**Summary of Public Comments  
and  
Department of Environment, Great Lakes, and Energy (EGLE) Responses  
to  
Wolverine World Wide’s Proposed  
House Street Property Work Plan – Final Remedy  
Public Comment Period: June 9, 2022 – July 31, 2022**

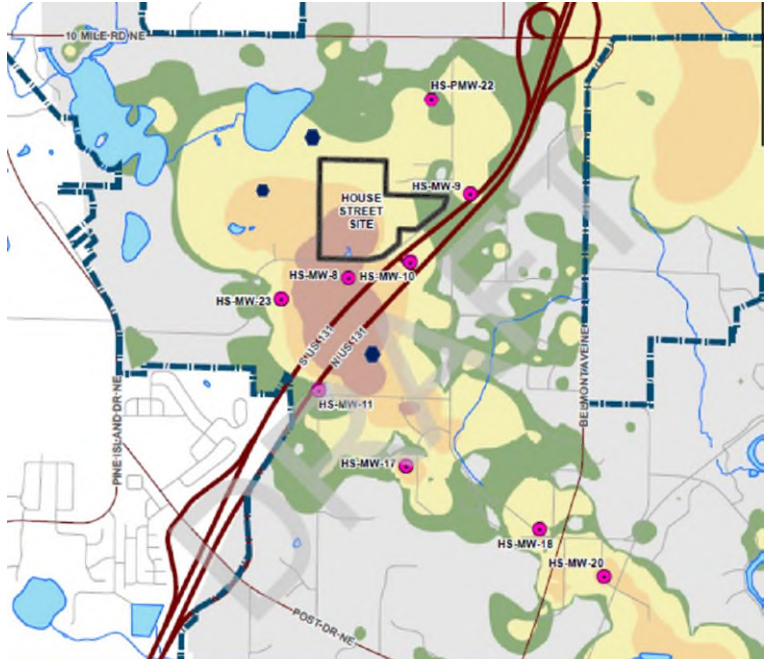
Commenter	Comment	EGLE Response
	<p>issues related to air quality, fugitive dust, landscaping, and monitoring. Our concerns are summarized below. Since the FR document does not follow a logical numbering system, our comments reference the actual number in the combined PDF.</p> <p><b>Air Quality</b></p> <p>Our air quality concerns are related to the landfill gas calculations, PFAS air emissions from vented landfill gas, and the lack of a fugitive dust control plan. GZA states in section 4.4 (p 11) that the site contains “49,000 cubic yards (CY) of organic waste and soil with waste materials is estimated to be approximately 34,000 CY for a total estimated volume of 83,000 CY. Additionally, the site vegetation removed during construction will be placed under the caps as described in the FS.” The air emission calculations for methane by GZA for a Major Source permit (Section 41. p 8) did not include the new organic waste stream they will generate by clear cutting, grubbing, and grinding the site vegetation on 40 acres (Section 4.2.1.4 p 36). The average weight of timber from clear cutting is 87 tons/acre (1)<sup>1</sup>. We estimate that the House Street site contains at least 50 tons/acre due to less tree density plus additional material from grubbing (removing stumps, vegetation, and roots) that will result in more organic matter than just clear cutting. For the 40 acre site, we estimate that clear cutting and grubbing will generate 2,000 tons or 8,000 cu yds of methane producing vegetation waste. It should be noted that yard waste is banned from landfill disposal in Michigan. We request that the Air Quality conduct an independent review of the air emissions of existing and new waste added to see if the disposal site will require permitting as a Major Source.</p> <p>GZA opined extensively about the ability of trees to accumulate PFAS by phytoremediation in their Phyto-Cap alternative for House St (February 19, 2021). Undoubtedly, the trees and vegetation along with the contaminated site soil attached to the stumps and roots will contain PFAS. Consequently, the new waste stream GZA omitted from the methane calculations will also contain PFAS. Since PFAS from the new wood and plant waste plus the existing site waste can be degraded</p>	<p><b>Air Quality</b></p> <p>According to the Air Quality Division, the capped landfill will not be subject to regulations based on the estimated landfill gas emissions. Emissions of Non-Methane Organic Compounds (NMOC) as well as all other regulated pollutants will be below Major Source applicability thresholds (34 tons per year of NMOC).</p> <p>A Fugitive Dust Plan will be implemented to minimize dust/particulate emissions from working areas and roadways (see Appendix C of the Work Plan). The Fugitive Dust Plan will be overseen by the Air Quality Division under Air Pollution Control Rule 37I. If the need for modification of the plan should arise, the Air Quality Division has the authority to do so.</p> <p>Volatile PFAS degradation compounds are at least ten times less toxic than PFOS or PFOA. The duration and intensity of volatile PFAS degradation</p>
